DEVELOPMENT APPLICATION ASSESSMENT REPORT

DA2020/1201

Responsible Officer:	Thomas Burns
Land to be developed (Address):	Lot 141 DP 11162, 39 Prince Edward Road SEAFORTH NSW 2092
Proposed Development:	Alterations and additions to a dwelling house.
Zoning:	Manly LEP2013 - Land zoned R2 Low Density Residential
Development Permissible:	Yes
Existing Use Rights:	No
Consent Authority:	Northern Beaches Council
Land and Environment Court Action:	No
Owner:	Susan Jane McCall
Applicant:	Susan Jane McCall

Figure 1: existing and proposed shadowing of 37 Prince Edward Road at 9am June 21

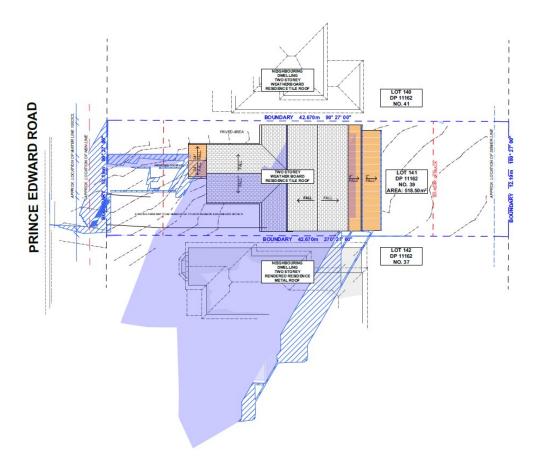
Concern was raised from the neighbour at 37 Prince Edward Road (southern adjoining site) noting that the development will result in significant overshadowing of the adjoining property, specifically to the rear yard.

Clause 3.4.4.1 of the MDCP 2013 stipulates that new development (including alterations and additions) must not eliminate more than 1/3 of the existing sunlight accessing the private open space of adjacent properties from 9am to 3pm on June 21 (winter solstice). It is important to note that the private open space on the adjoining site is located within the rear yard.

Given the east-west orientation of the site, the adjoining site will be subject to overshadowing. The extent of the overshadowing is depicted in the below shadow analysis, which indicates the level of overshadowing that the adjoining site is currently subject to and the extent of the overshadowing that will result as a consequence of the development.

As demonstrated in the above shadow analysis, the development does not eliminate more than 1/3 of the existing sunlight accessing the rear yard at 37 Prince Edward Road. Therefore, the development complies with Clause 3.4.4.1 of the MDCP 2013.
